GLADSTONE – FITZROY

PIPELINE PROJECT

Environmental Impact Statement

Supplementary Report

Figure 1- Locality Map (overview)

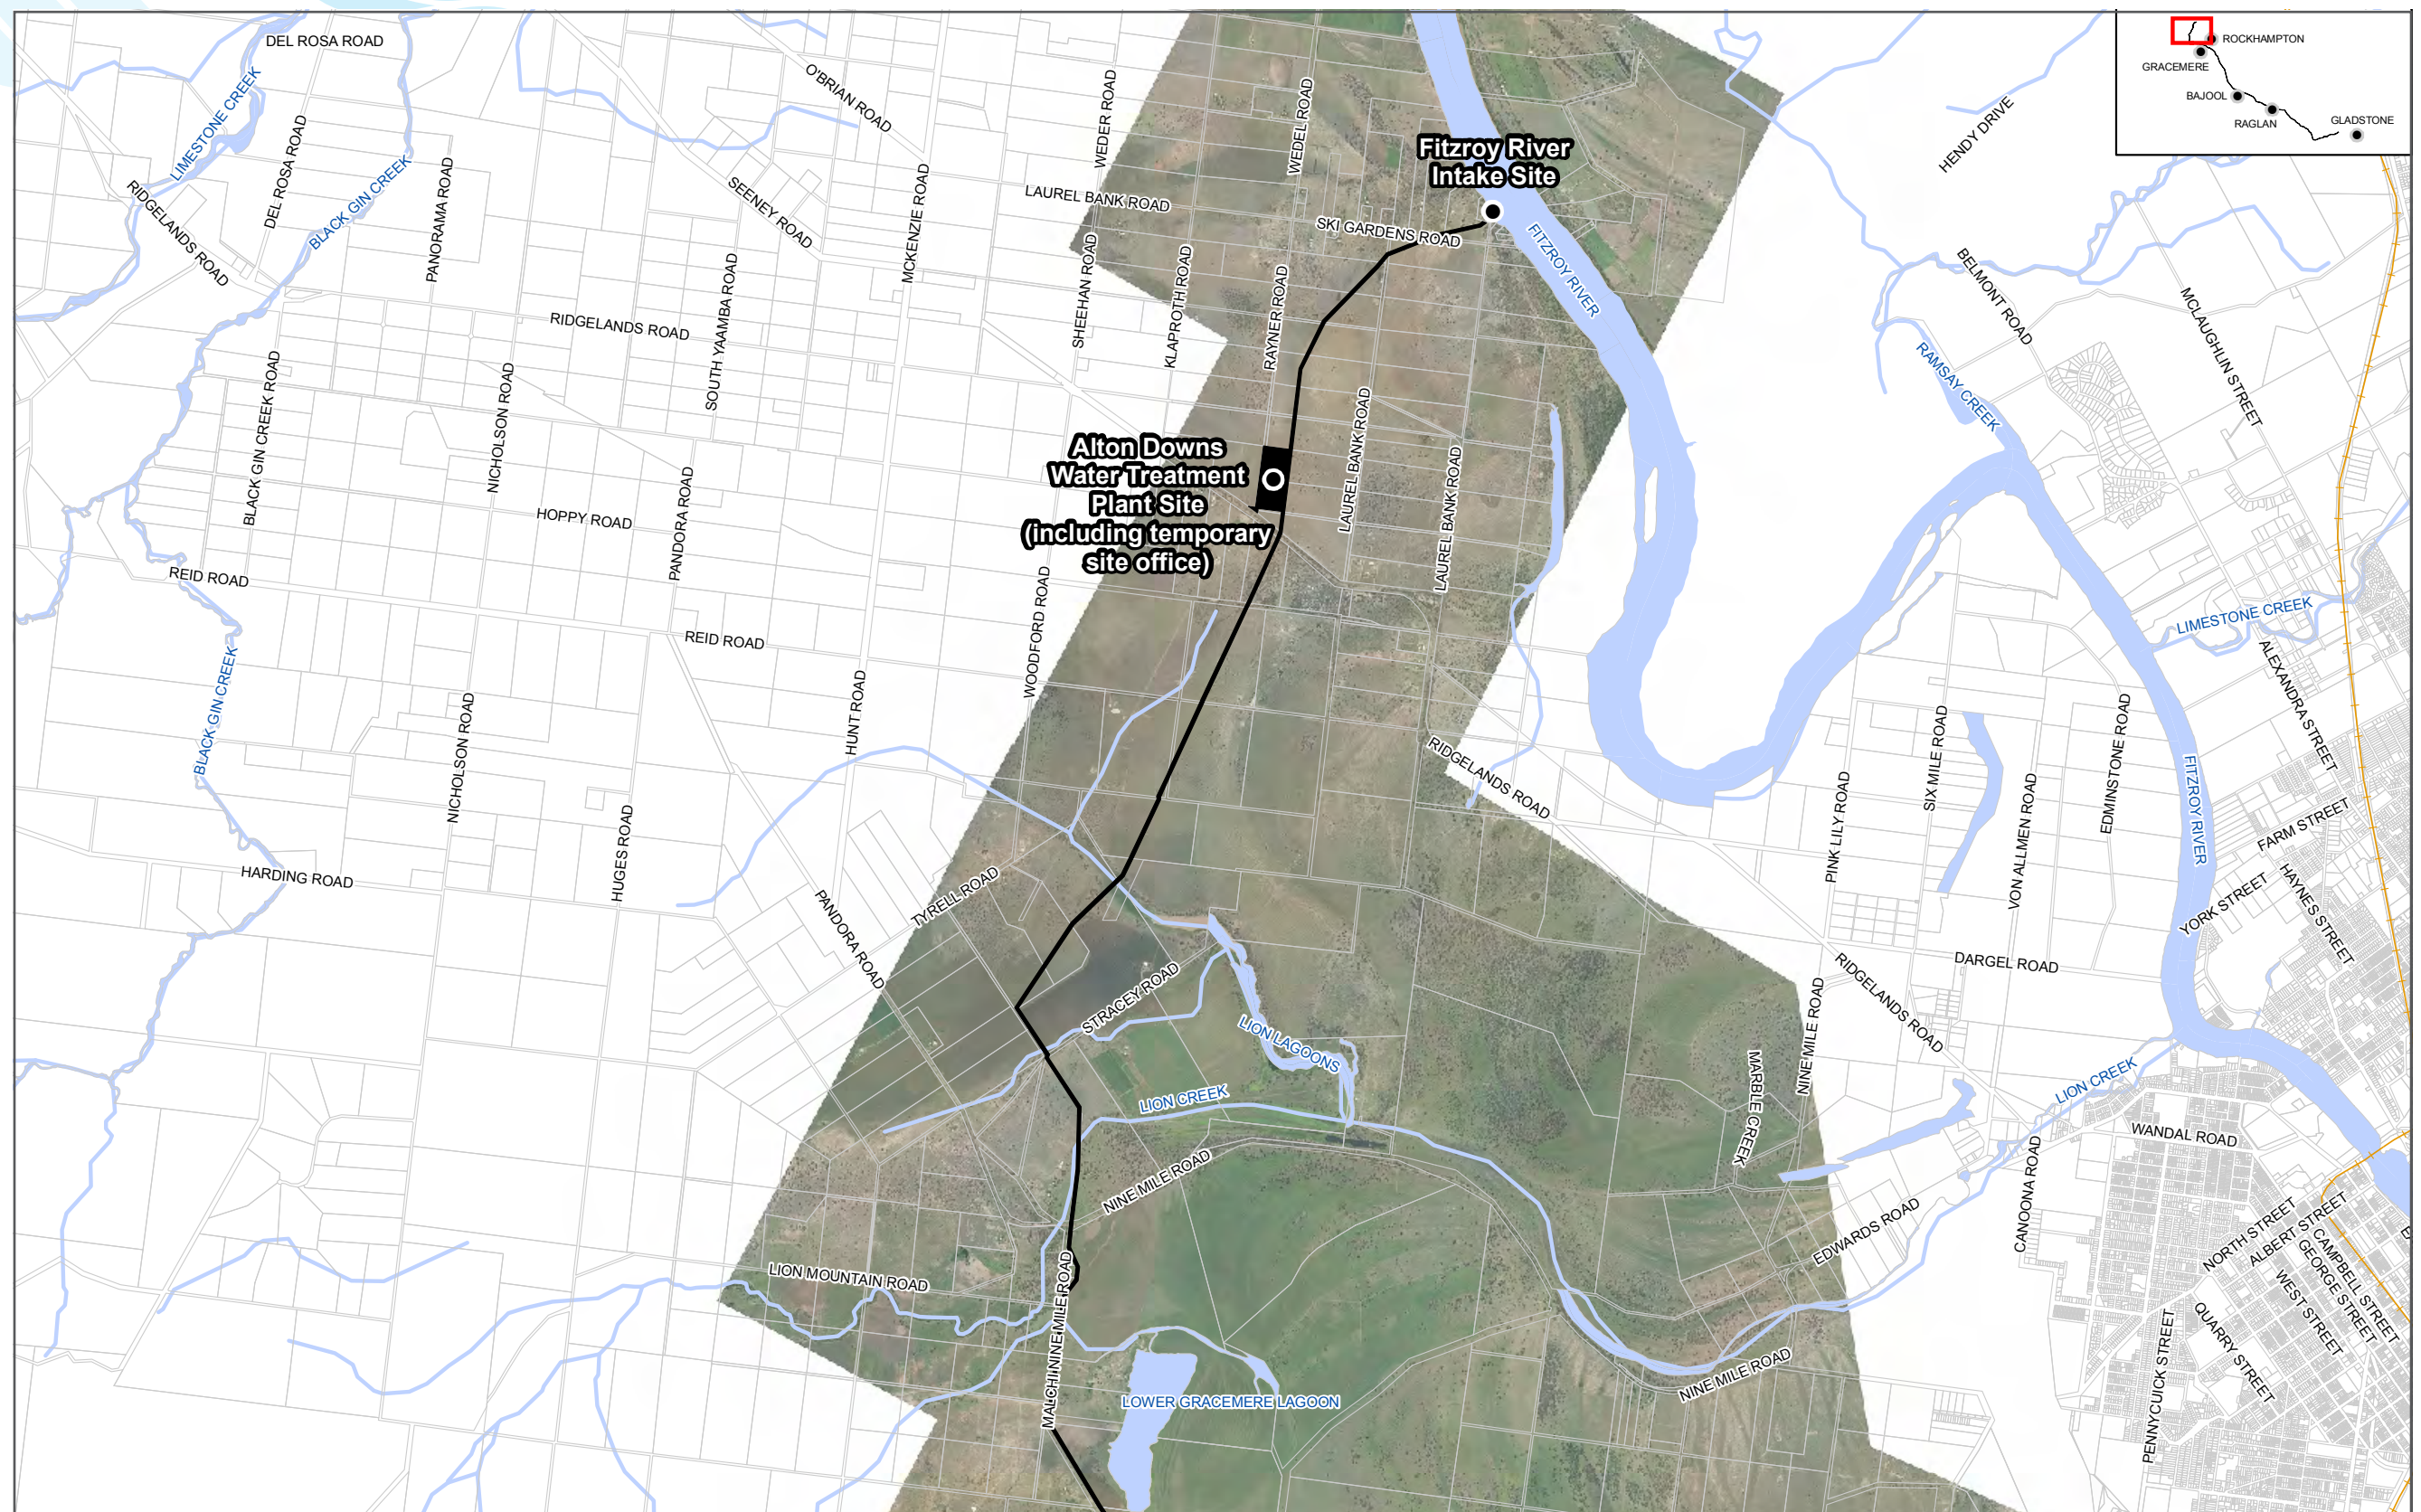
11.5	Gladstone SDA and SGICSDA boundary	DIP suggests that the EIS include a map indicating the pipeline route with associated SGICSDA boundary and GSDA boundaries.	Figure 1 Locality Map and 4.11.4

Figure 1 Locality Map includes a detailed mapset showing the location of the SGICSDA and the GSDA.

Gladstone - Fitzroy Pipeline EIS
Supplementary Report
**Figure 2 - Existing Infrastructure -
Bajool to Gladstone**
Sheet 2 of 2

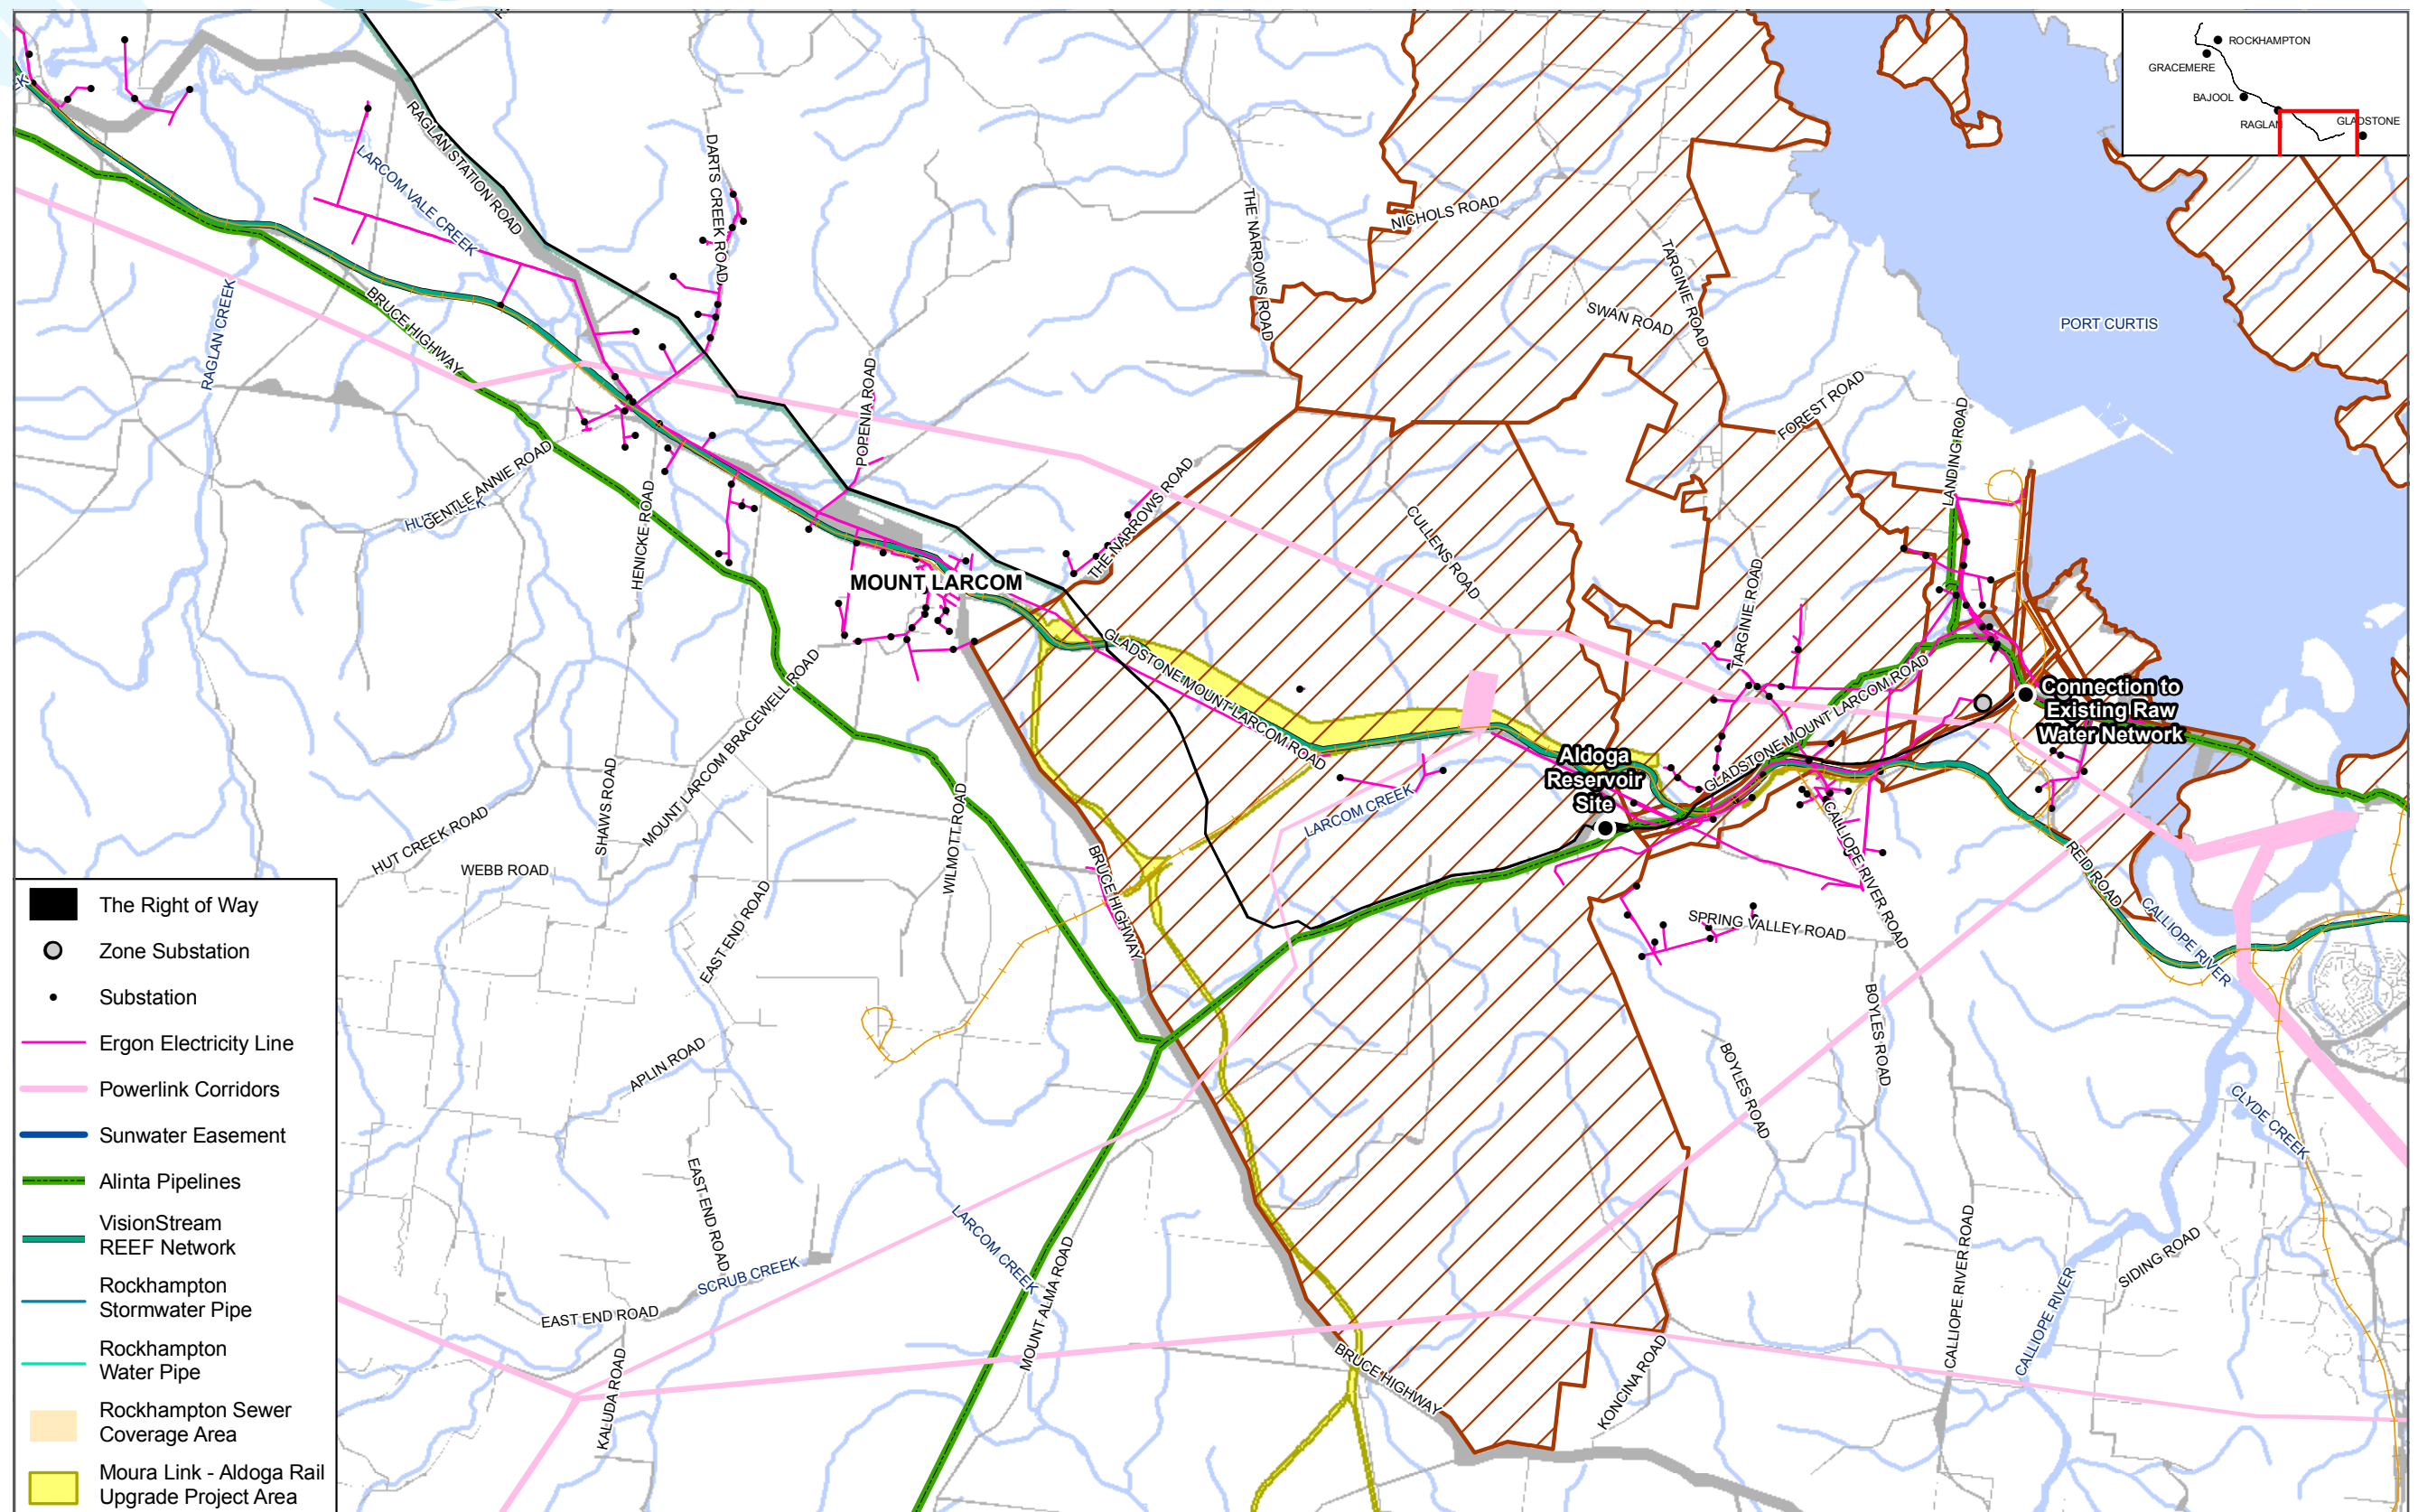
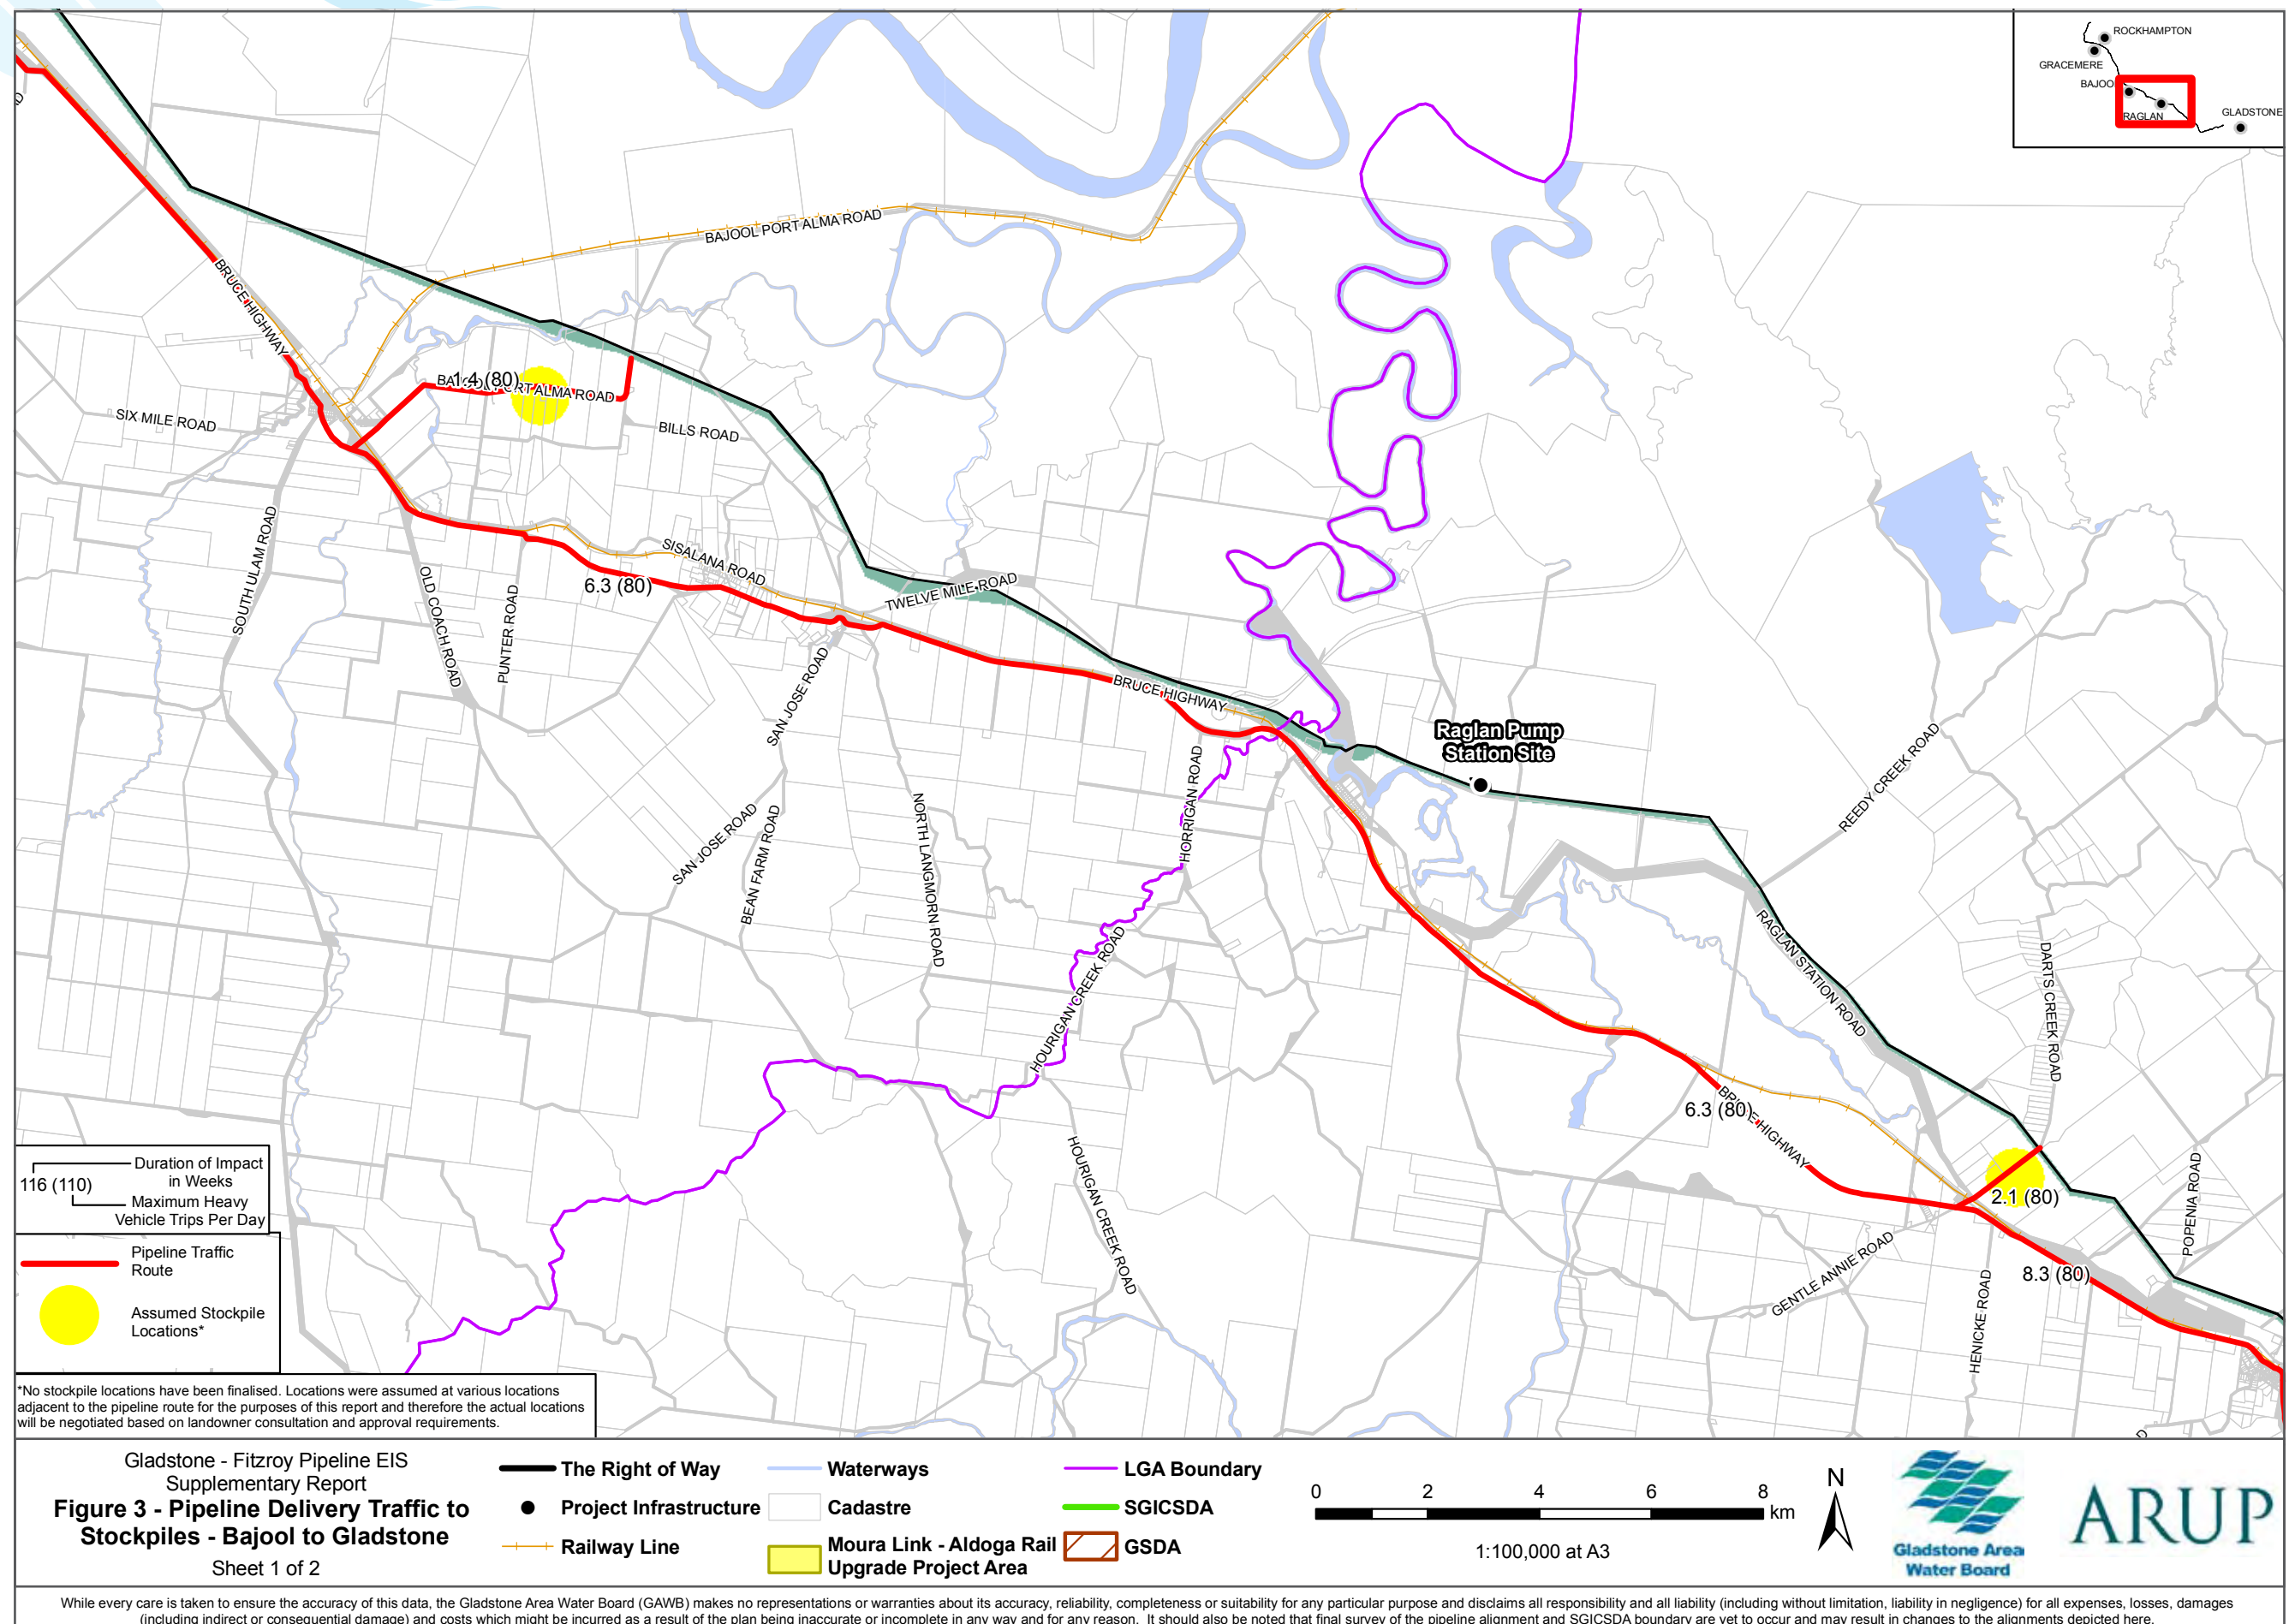
No.	Submitter	Issue No.	Key Issue	Summary of Submission	Response (Section of the Supplementary Report)
		5.2	Mapping	QT suggests that Figures 4.6 and 4.12 in Chapter 4 of the EIS, Land Use and Infrastructure include the proposed Moura Link - Aldoga Rail Project.	4.5.2 and Figure 2 and 3

QT requests that Figure 4.12 (Chapter 4, Land Use and Infrastructure) and Figure 13.9 (Chapter 13, Transport and Access Arrangements) be updated to include QR's proposed Moura Link – Aldoga Rail Project.
